**Planning Department
Transportation Development Services Section**

Re: Certification Submittal for Final Building Certificate of Occupancy for
Richmond Street Studios, [K-16 / D66]
117 Richmond SE
Architect's Stamp Dated 12/13/06

Re: Certification Submittal for Final Building Certificate of Occupancy for
Richmond Street Studios, [K-16 / D66]
117 Richmond SE
Architect's Stamp Dated 11/15/06

(ALTERNATE FOR ADA COMPLIANCE)
(SIDEWALK AT PROPERTY LINE)

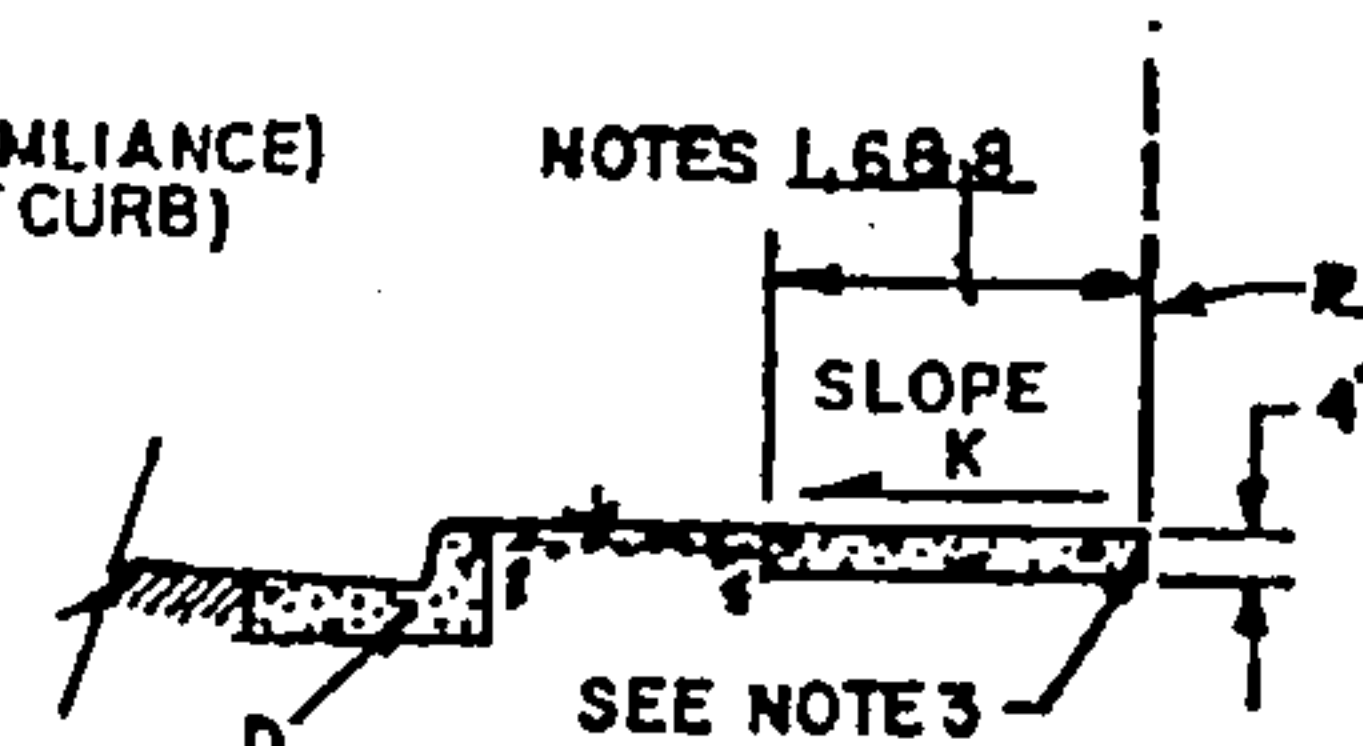
The TCL / Letter of Certification submitted on November 15, 2006 is not sufficient for acceptance by this office for final Certificate of Occupancy (C.O.). The Letter of Certification needs to have the following phrase as part of your wording, 'Substantial Compliance'. The entrance to the studio has need been constructed per the approved site plan. The drivepad needs to provide an ADA access route across the entrance which is not the case in accordance to field inspection.

I am resubmitting this Traffic Circulation Certification for Final Certificate of Occupancy for our project the Richmond Street Studios at 117 Richmond, SE. We have successfully addressed issues related to an ADA access route across the entrance drivepad per your field inspection instructions stated in your letter of November 16, 2006.
